NO.	REVISIONS	DATE	BY
01	ADDENDUM 1 - THERMISTOR RELAY	2019-08-22	CJR
00	ISSUED FOR CONSTRUCTION	2019-08-01	SLF

NORTH END SEWAGE TREATMENT PLANT

CONNECTION DIAGRAM
 VFD-D376
 MIXING PUMP

CITY DRAWING NUMBER: 1-0101D-E0026-001

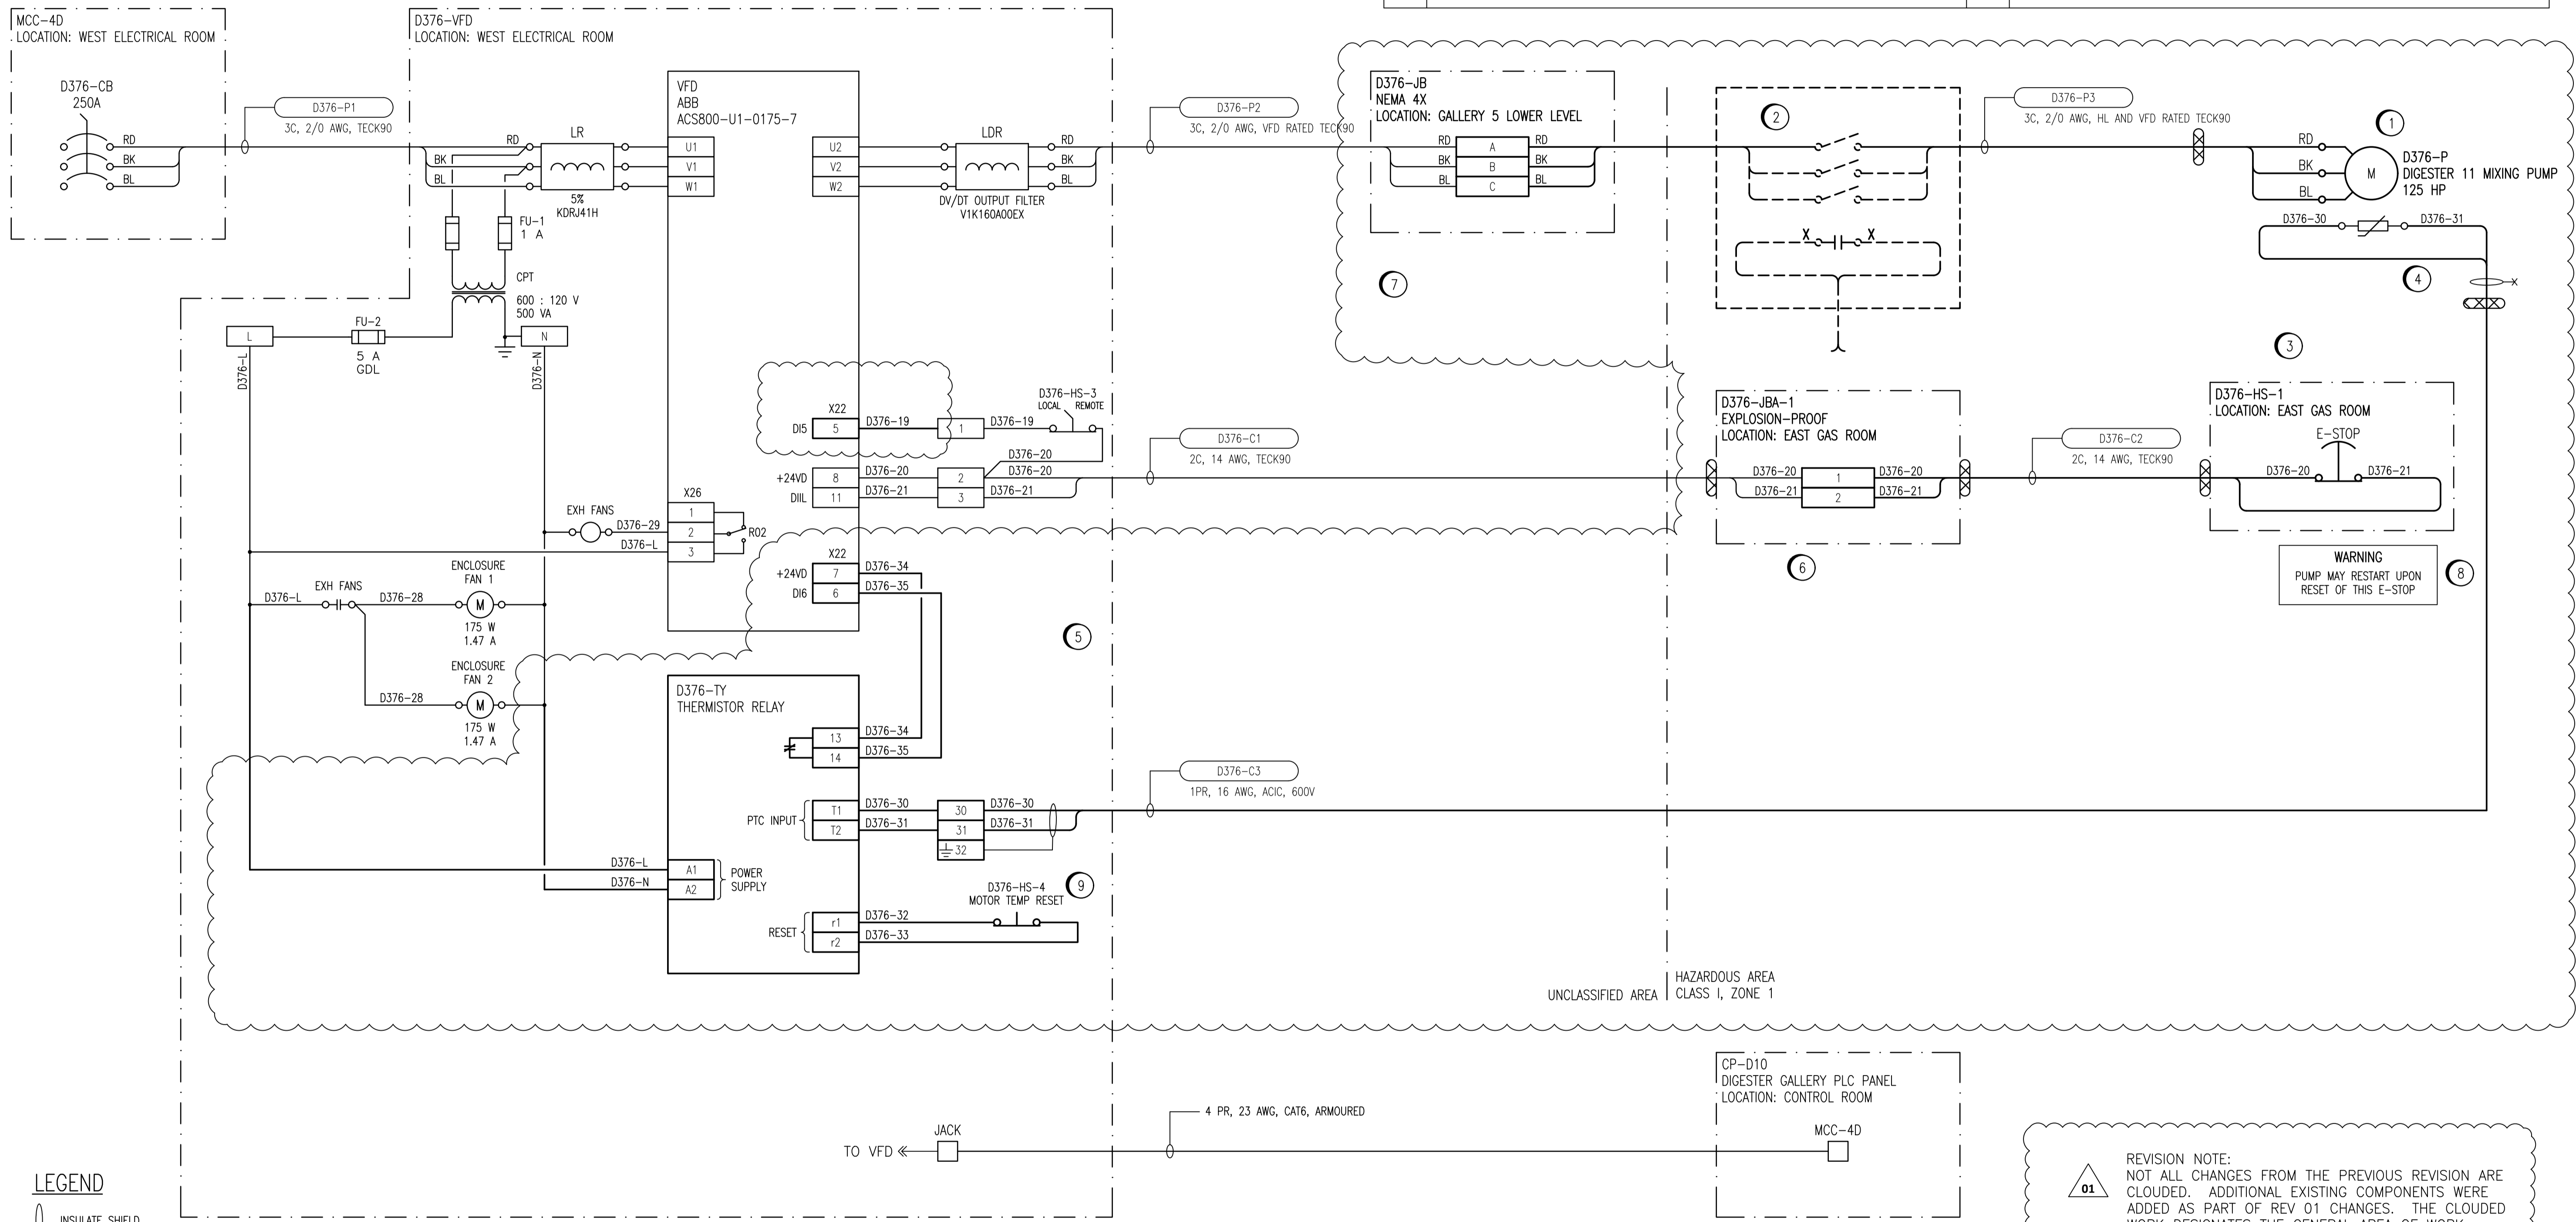
- CONSTRUCTION NOTES:**
- REPLACE EXISTING MOTOR WITH NEW EXPLOSION-PROOF MOTOR.
 - DISCONNECT AND SALVAGE DISCONNECT SWITCH. REMOVE AUXILIARY CONTACT WIRING CURRENTLY INTEGRATED INTO E-STOP CIRCUIT.
 - INSTALL NEW EXPLOSION-PROOF EMERGENCY STOP SWITCH. RE-WIRE AS SHOWN.
 - RUN NEW CABLE AND CONNECT THERMISTOR WIRING AS SHOWN.
 - MODIFY VFD CABINET AS SHOWN. INSTALL DIN RAIL AND WIRING DUCT AS REQUIRED. SET VFD PARAMETERS AS REQUIRED AND COMMISSION.
 - REMOVE EXISTING NON-HAZARDOUS RATED JUNCTION BOXES. INSTALL NEW HAZARDOUS RATED JUNCTION BOX WITH TERMINALS TO EXTEND WIRING.
 - INSTALL NEW JUNCTION BOX WITH 200A RATED TERMINALS AND APPROPRIATELY SIZED FOR CABLE BEND RADIUS. LOCATE IN CEILING SPACE OF GALLERY BELOW THE EAST GAS ROOM.
 - PROVIDE WARNING LAMACOID IN ACCORDANCE WITH E14.
 - INSTALL NEW RESET BUTTON IN THE DOOR.

REVISION NOTE:
 NOT ALL CHANGES FROM THE PREVIOUS REVISION ARE CLOUDED. ADDITIONAL EXISTING COMPONENTS WERE ADDED AS PART OF REV 01 CHANGES. THE CLOUDED WORK DESIGNATES THE GENERAL AREA OF WORK REQUIRED BY THE CONTRACTOR.
